**RE: Lot 5 Block 6 Unit 19 SAD 228
Volcano Cliffs Subdivision
7816 Urraca St. NW
Request for Permanent C.O. – Not Accepted
Engineers Stamp Date 11/22/16 (D10D003F25)
Certification Dated: 2/19/18**

DRAINAGE AND TRANSPORTATION INFORMATION SHEET (REV 09 2015)

AS BUILT
GRADING AND DRAINAGE PLAN
LOT 5, BLOCK 6, UNIT 19, VCS
ADDRESS: 7816 Urraca Street, NW

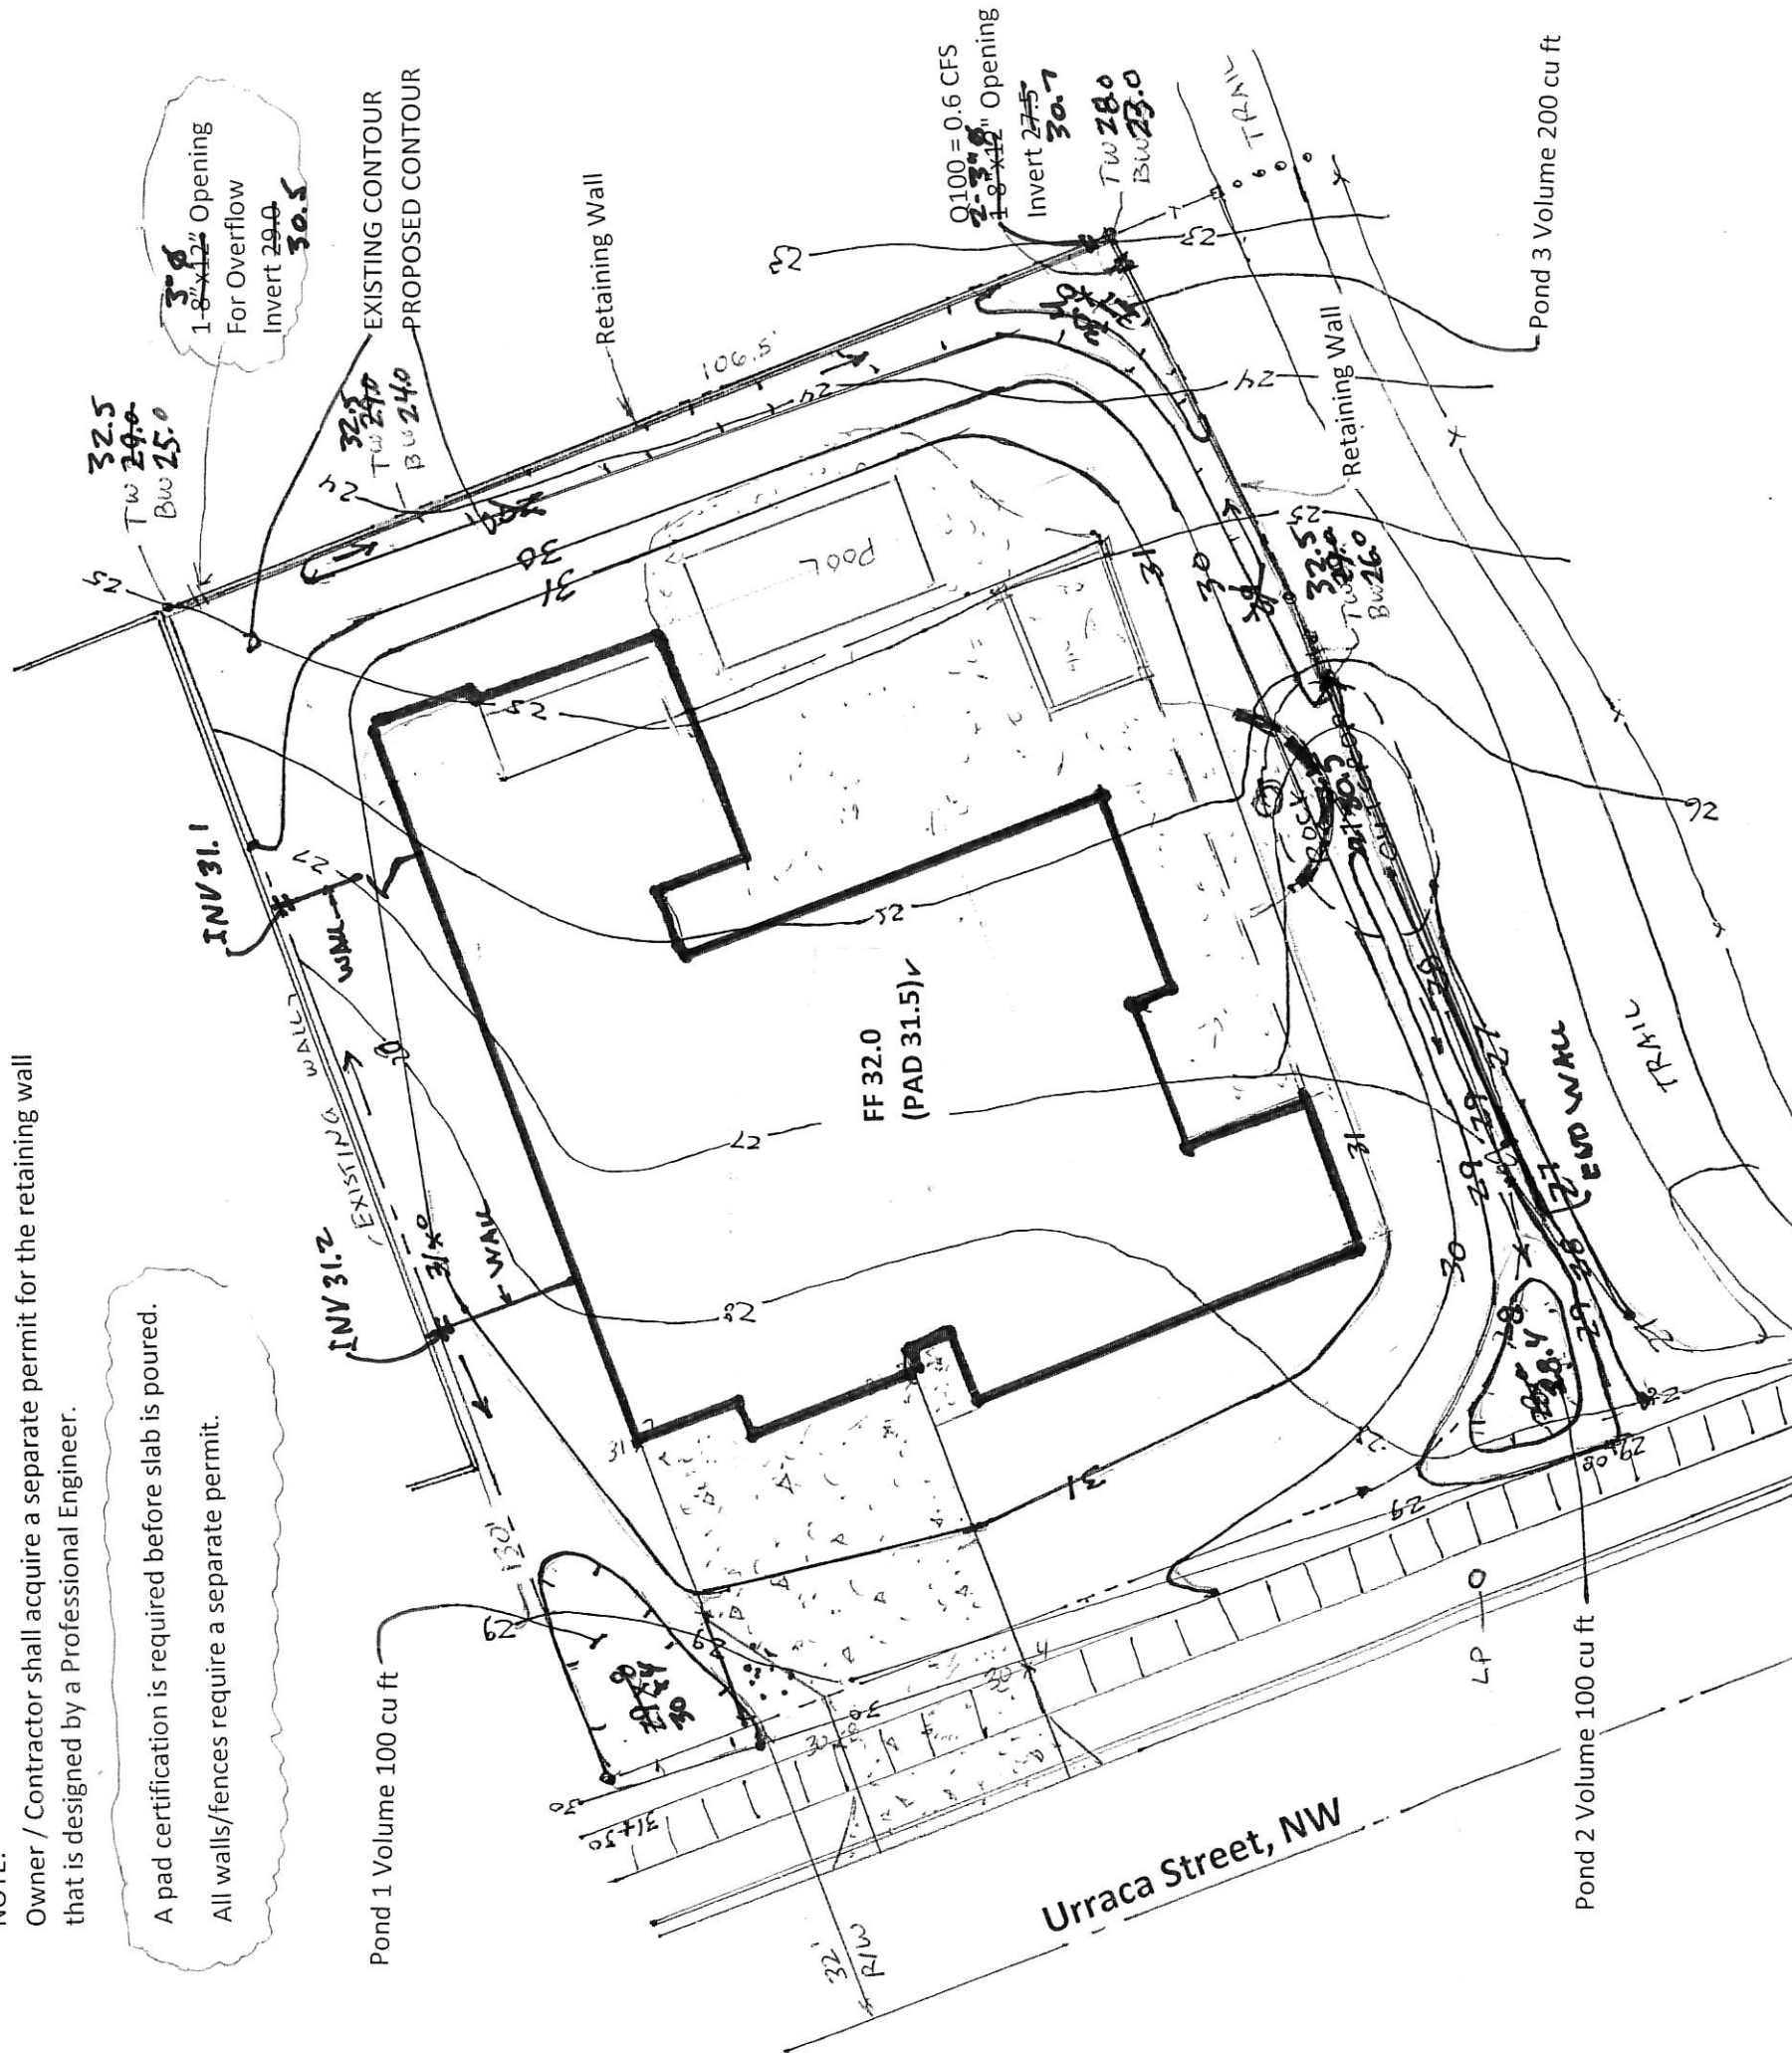
- Provide the sidewalks and drive pad which are missing.
- All debris and concrete must be removed in and around the entire site.
- The flows on the east side of the structure will not enter the pond in the Southeast corner. Provide a swale to assure these flows will enter the pond.
- Provide a way for the flows to leave the open areas near the structure.
